Lower Minnesota River Watershed District Board of Managers Meeting Wednesday, June 17, 2020

Agenda Item
Item 6. I. -Project Reviews

**Re:** Prairie Heights Preliminary Review (Permit No. 2020-103)

# Figure 1: Prairie Heights Preliminary Review Eden Prairie, MN 09-June-2020

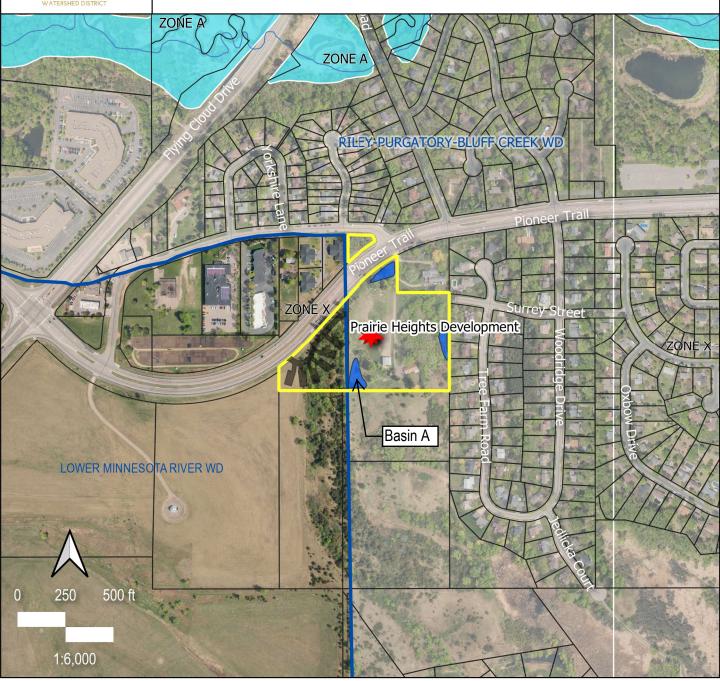
The Prairie Heights project spans the boundary between the District and the Riley-Purgatory-Bluff Creek Watershed District (RPBCWD). The extension of Surrey Street and construction of six single-family homes comprise the extent of the proposed improvements within the District. The portion of the Prairie Heights project within the District flows into RPBCWD under both existing and proposed conditions, and all proposed stormwater best management practices (BMPs) are located within the RPBCWD boundary (Figure 1).
